UMANSKY SUBARU

REVISIONS TO APPROVED ARB DESIGN

DESIGN
DEVELOP

10 | 11 | 2021

PROPOSED REVISED ELEVATION

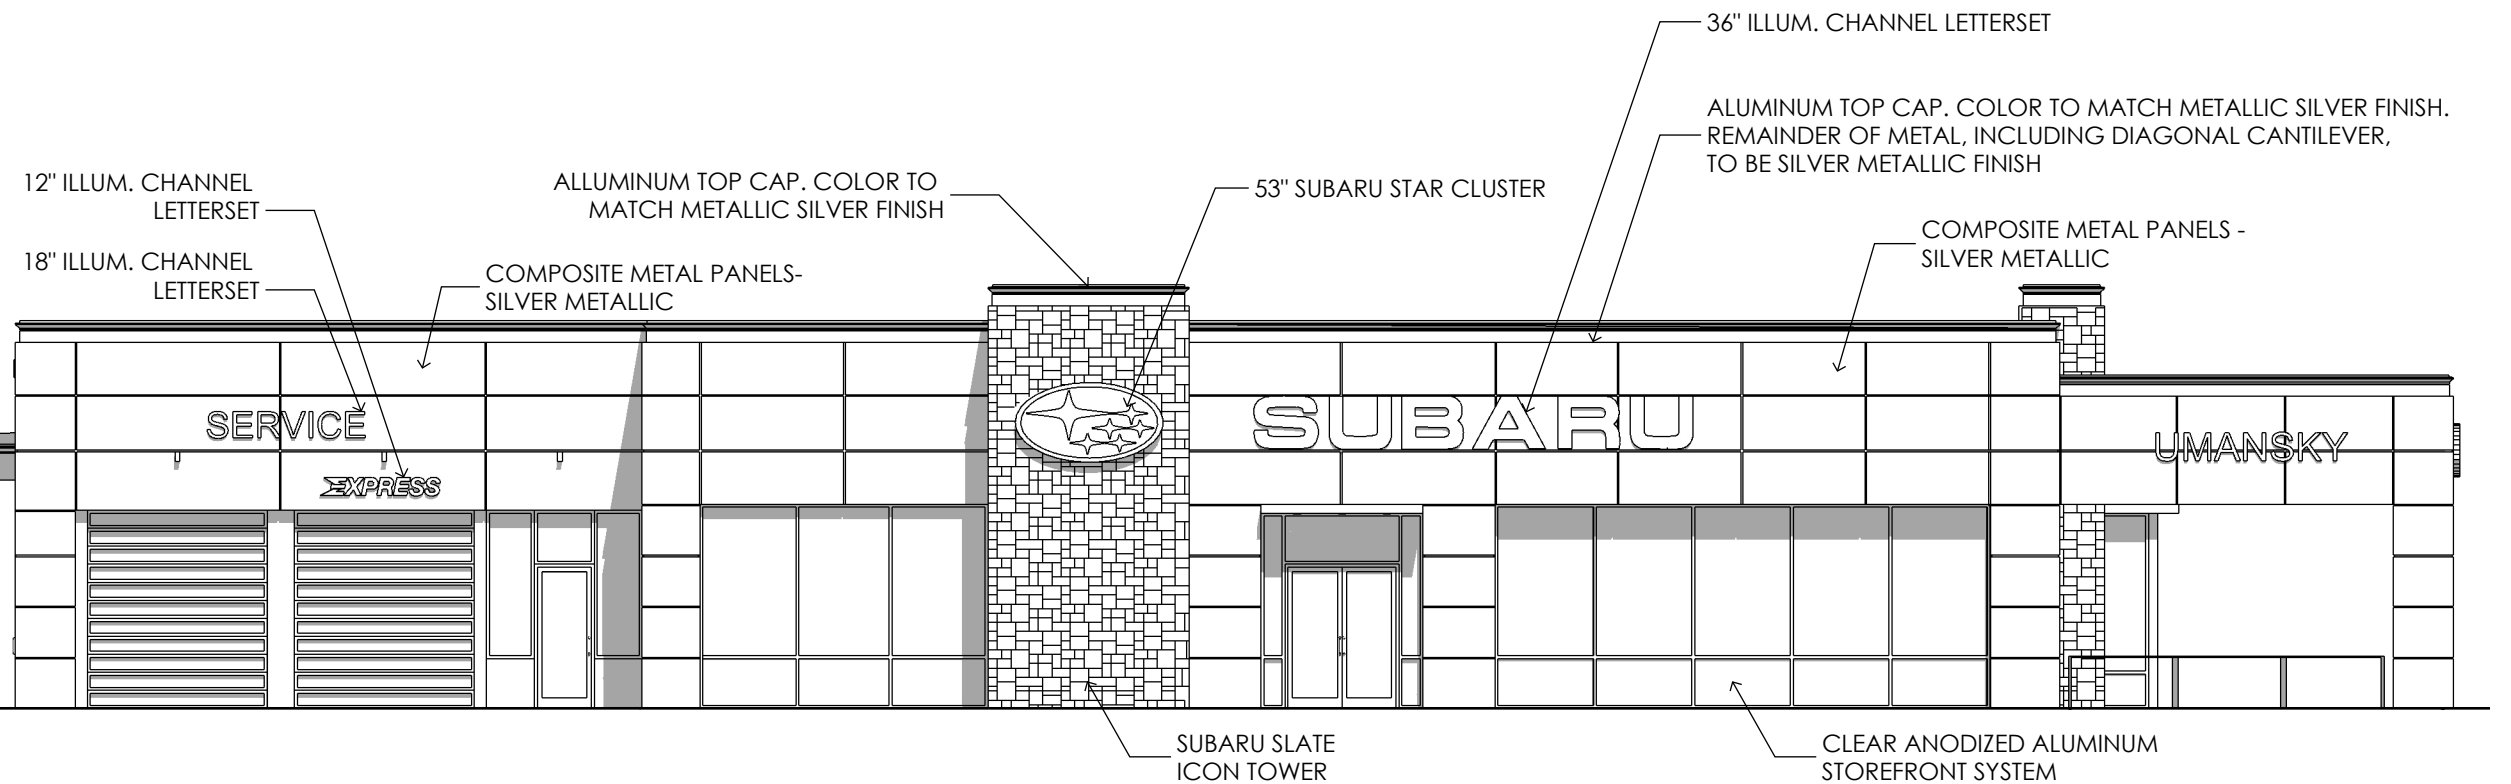
REVISION 1: LOWER THE HEIGHT OF THE SERVICE LANE PARAPET TO MATCH HEIGHT OF DELIVERY PORTICO TO REINFORCE BUILDING HEIRARCHY

REVISION 2: RE-INTRODUCE THE BLUE SHADOW LINE FASCIA ABOVE SALES AREA

- REVISION 3:** DE-EMPHASIZE SLATE TOWER ELEMENT:
- REMOVAL OF SUBARU STAR CLUSTER LOGO
 - REMOVAL OF SILVER SHADOW LINE FASCIA, REPLACE WITH TYPICAL PARAPET COPING CAP

EXTEND THE SALES AREA PARAPET TO THE EDGE OF EXISTING CONSTRUCTION /
UTILIZE NEW BUILDING ADDITION TO PROVIDE STRUCTURE FOR PARAPET WALL
